**RE: Grading and Drainage Report for QWEST Academy (D19-D4A) Dated
November 1, 2002**

**RE: QWEST - ACADEMY BUILDING ADDITION, Wyoming & Scott's Place(D19-D4A).
GRADING AND DRAINAGE PLAN FOR GRADING PERMIT, FOUNDATION
PERMIT, BUILDING PERMIT, AND SO#19 PERMIT APPROVALS. ENGINEER'S
STAMP DATED JUNE 8, 2001.**

ACADEMY BUILDING ADDITION

DESIGNED BY:	J. KELLEY	SCALE:	1"=20'
DRAWN BY:	B. ORTEGA	JOB NUMBER:	B01-1b
FILE NAME:	B01161C601.DWG	DATE:	9-19-01
DESCRIPTION:	GRADING & DRAINAGE PLAN MODIFICATIONS		
	C1

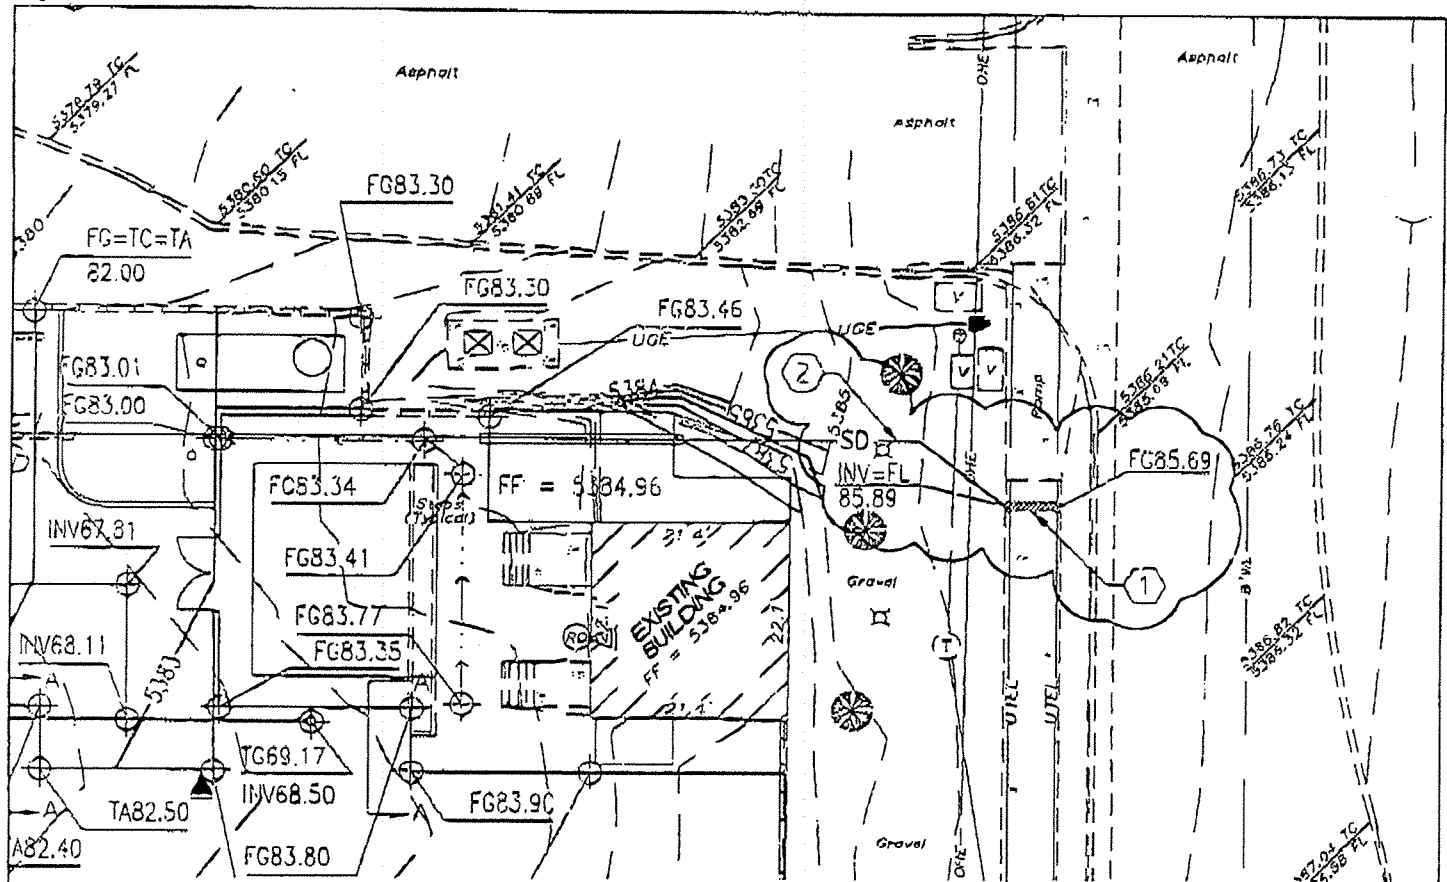
- 1 CONSTRUCT 1' WIDE SIDEWALK CULVERT PER COA STD DWG 2236.
- 2 INSTALL NEW 4" JOINTLESS POLY-PIPE PRESSURE STORM DRAIN LINE.

DESIGNED BY:	J. KELLEY	SCALE:	1"=20'
DRAWN BY:	B. ORTEGA	JOB NUMBER:	801-161-01
FILE NAME:	B01161C1001.DWG	DATE:	8-19-01
DESCRIPTION:	UTILITY PLAN MODIFICATIONS		C2

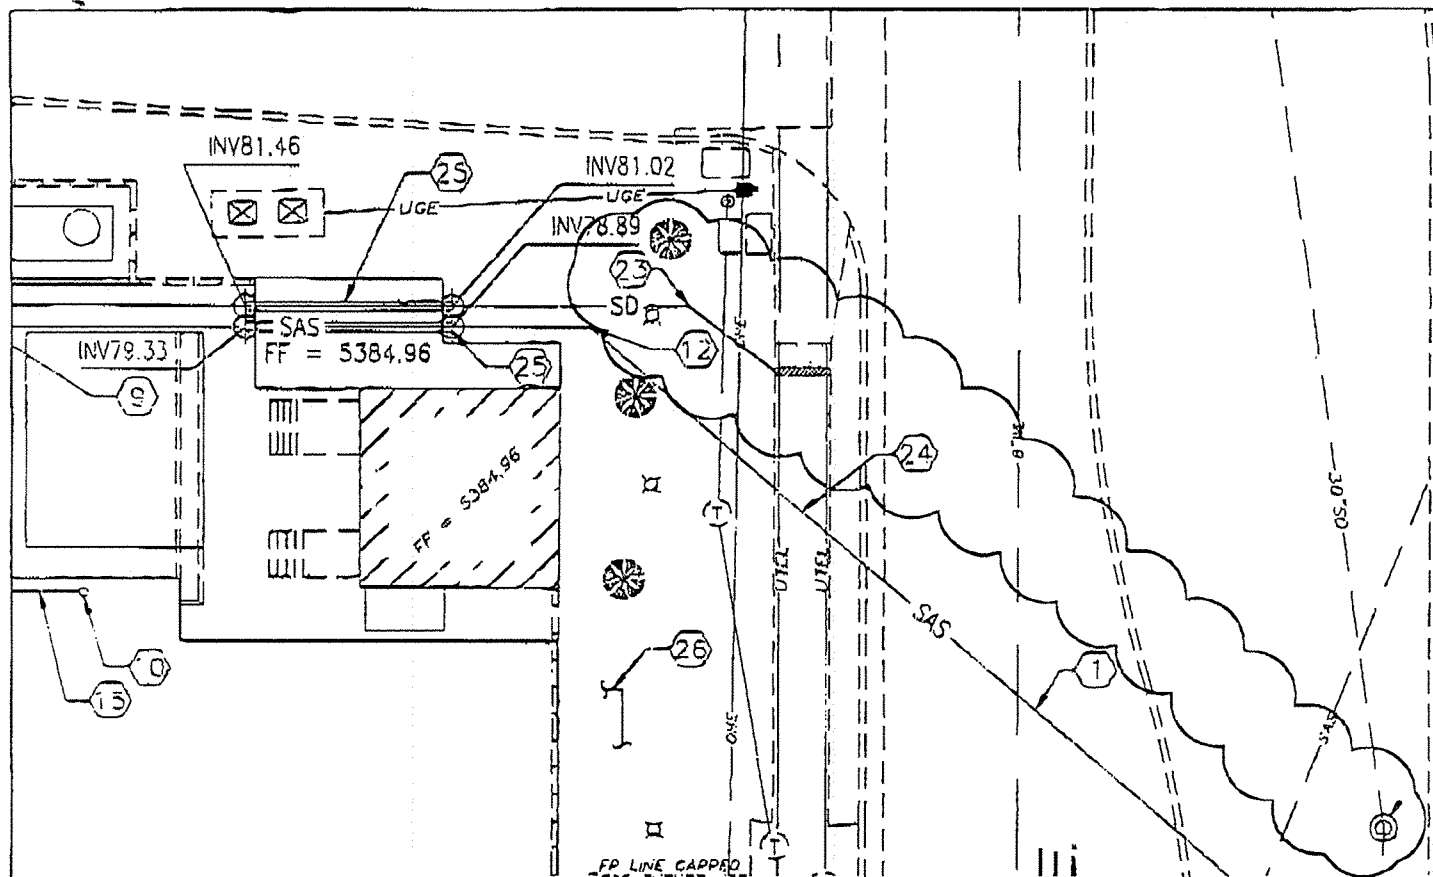
5 NOT USED.
22 NOT USED.
23 INSTALL 1~45° BEND.
